GENERAL ELECTRIC COMPANY, 175 CURTNER AVE., SAN JOSE, CALIFORNIA 95125
MC 682 (408) 925-5040

MFN 053-83
JNF 015-83

SUBJECT: IN THE MATTER OF 238 NUCLEAR ISLAND
GENERAL ELECTRIC STANDARD SAFETY ANALYSIS REPORT (GESSAR II)
DOCKET NO. STN 50-447

REVISED DRAFT RESPONSES

TABLE I
ISOLATOR POWER CABLE TABULATION

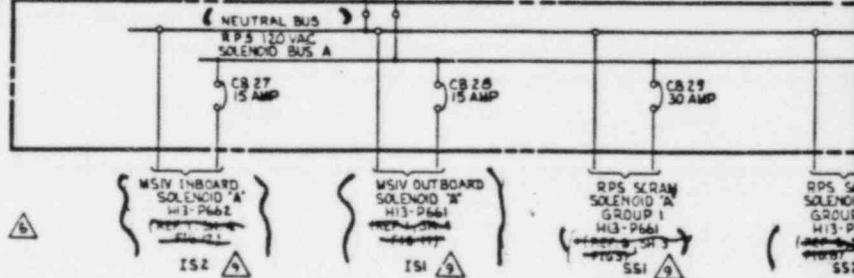
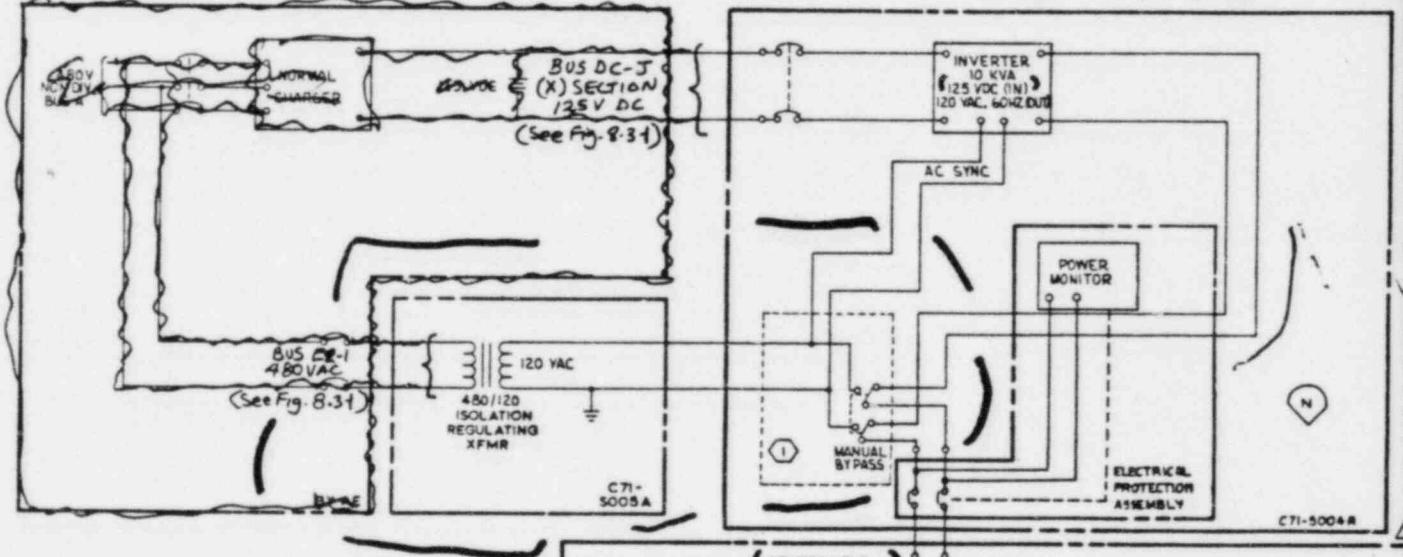
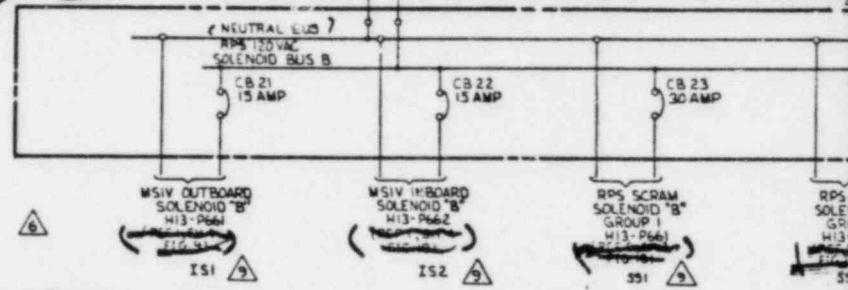
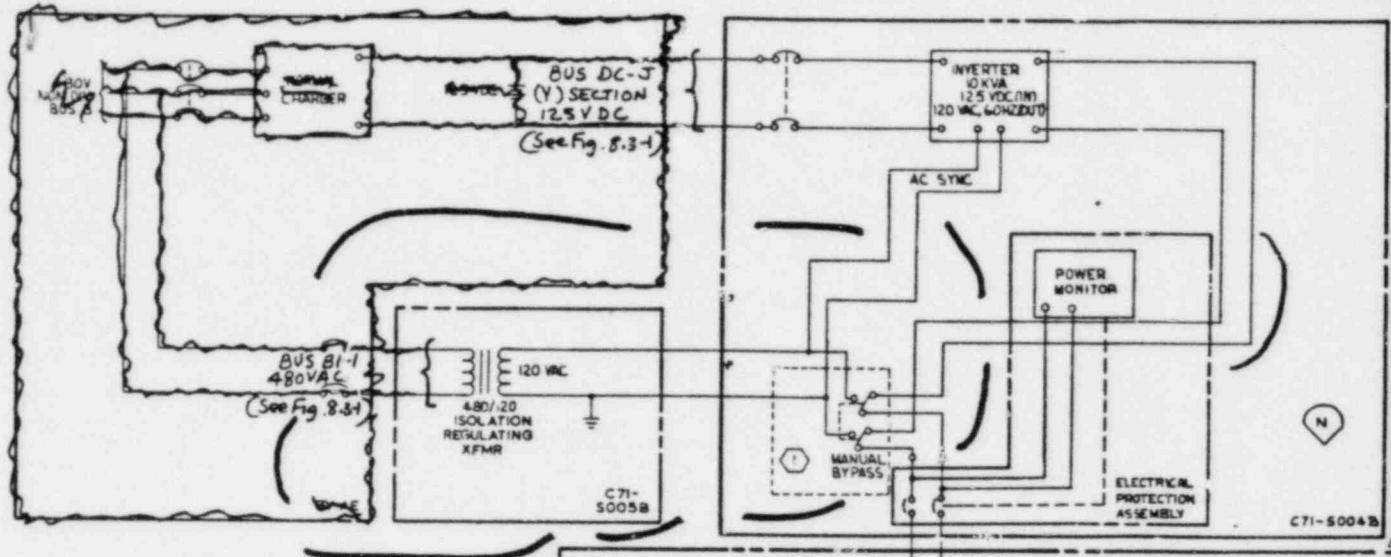
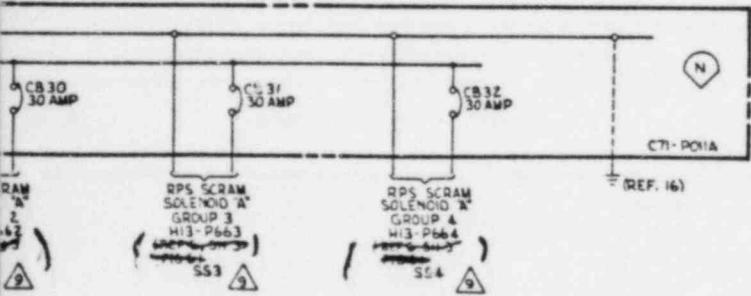
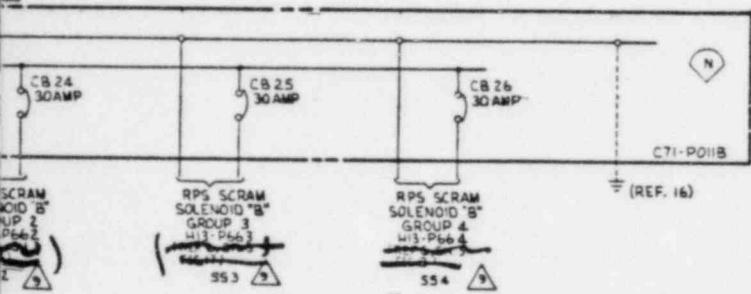
UPDATE GESSAR II FIG. 8.3-20C AS PER THIS DWG.

(① THE MANUAL BYPASS SWITCH IS A SYNCHRONIZED
MAKE-BEFORE BREAK SWITCH)
